To: T10 Technical Committee
 From: Rob Elliott, HP (elliott@hp.com)
 Date: 13 June 2006
 Subject: 06-279r0 SAS-2 Allow more than one ZSDS in a SAS domain

Overview

Figure 1 — Two ZPSDSes introduction

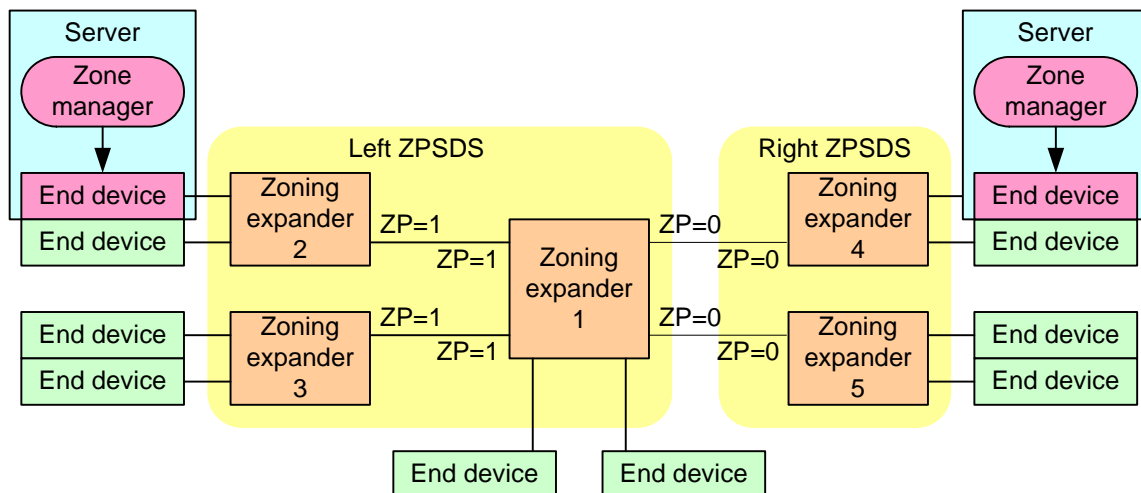
SAS-2 currently mandates that there be no more than one zoned portion of the service delivery subsystem (ZPSDS) per SAS domain. However, there is no way to enforce this and no reason to do so - a user can easily attach two zoned JBODs together, and they will communicate fine. Each ZPSDS has its own zone manager. How or whether those zone managers communicate to let devices attached to one ZPSDS talk to devices attached to the other is outside the scope of the standard. The zone group numbers in one ZPSDS has no relationship to the zone group numbers in the other ZPSDS.

Figure 1 shows two ZPSDSes. As long as the ZONE PARTICIPATING bits are set to zero at the boundaries, they can coexist.

Figure 4 — Three ZPSDSes example

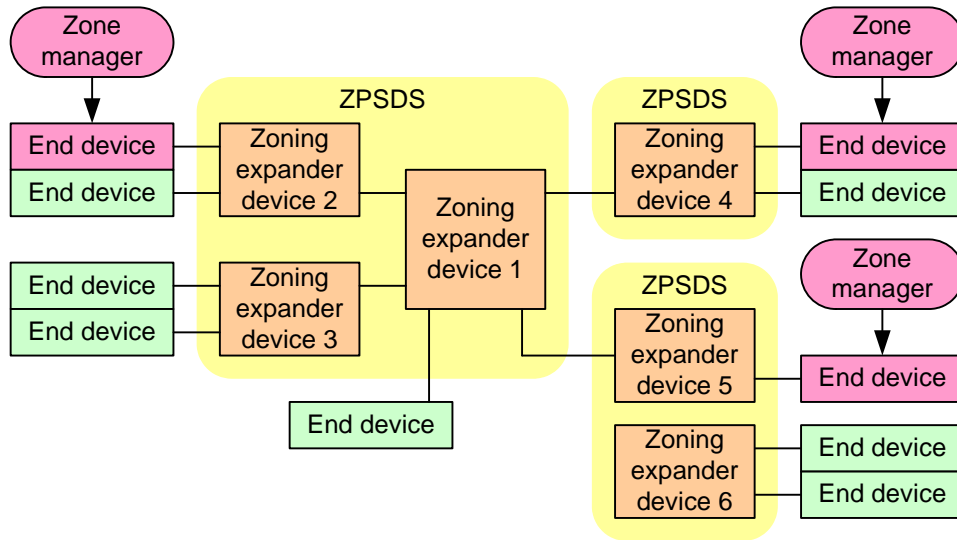
There ~~shall be at most one~~ may be any number of non-overlapping ZPSDSes in a service delivery subsystem. ~~The~~ A ZPSDS may encompass some or all of the service delivery subsystem.

Figure 4 shows an example of three ZPSDSes in a SAS domain.

Figure 6 — Example of a ZPSDS with the ZONE ADDRESS RESOLVED bit set to zero

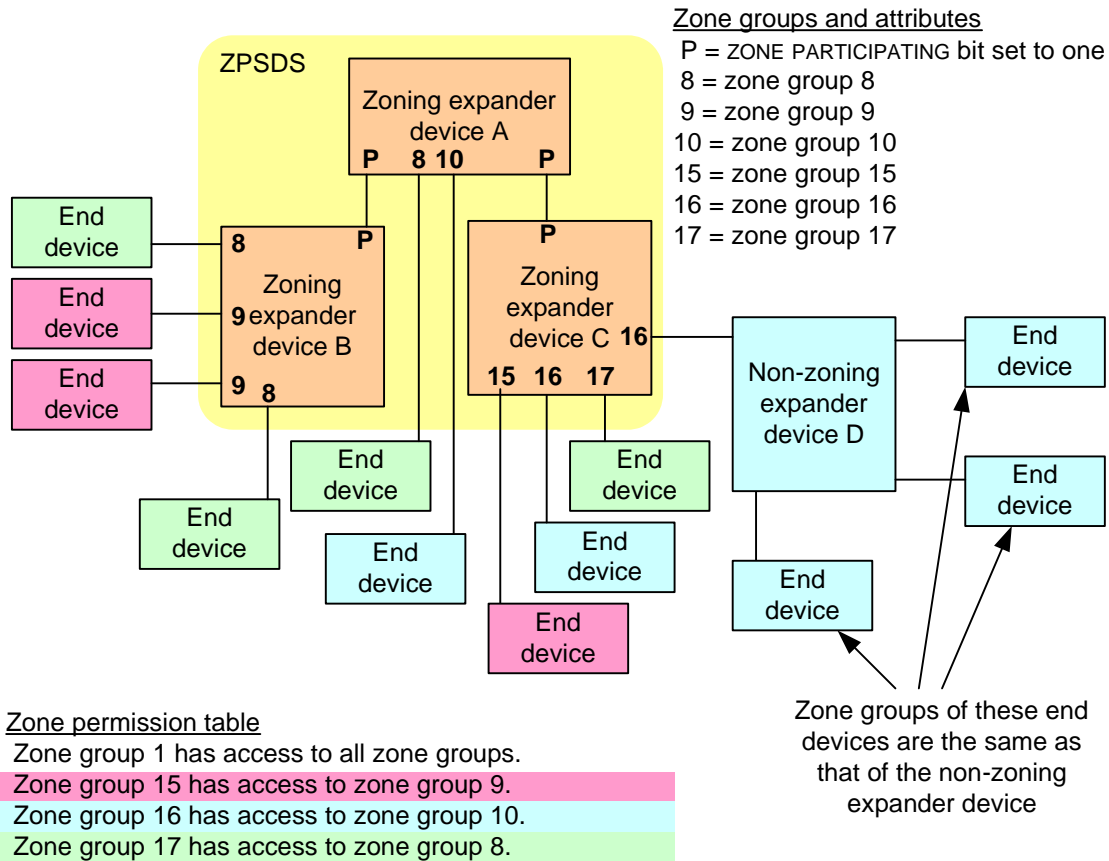
Editor's Note 3: the following figures were pulled out of 4.8.1.

Figure 6 shows an example of a ZPSDS in which the ZONE ADDRESS RESOLVED bit of the expander port of zoning expander device C that is attached to non-zoning expander device D is set to zero.

Figure 7 — Example of a ZPSDS with the ZONE ADDRESS RESOLVED bit set to one

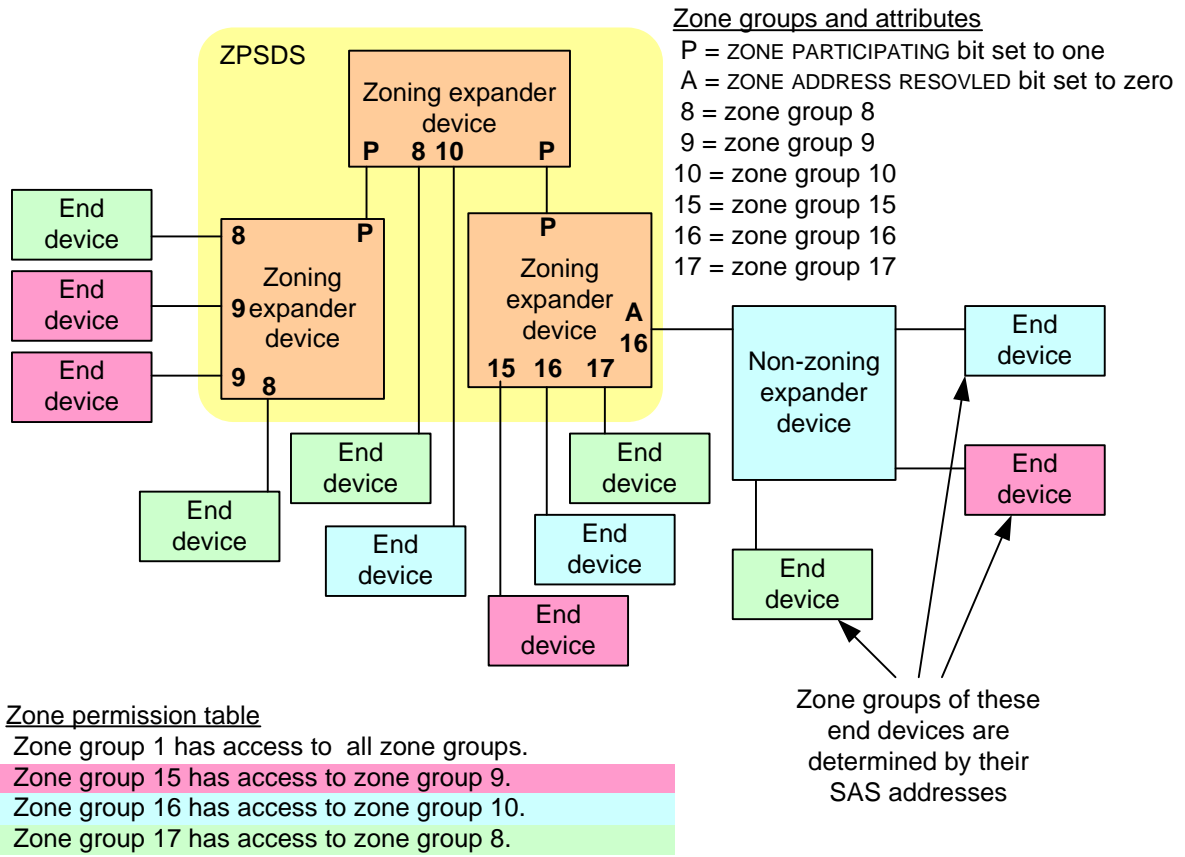
Figure 7 shows an example of a ZPSDS in which the ZONE ADDRESS RESOLVED bit of the expander port of zoning expander device C that is attached to non-zoning expander device D is set to one.
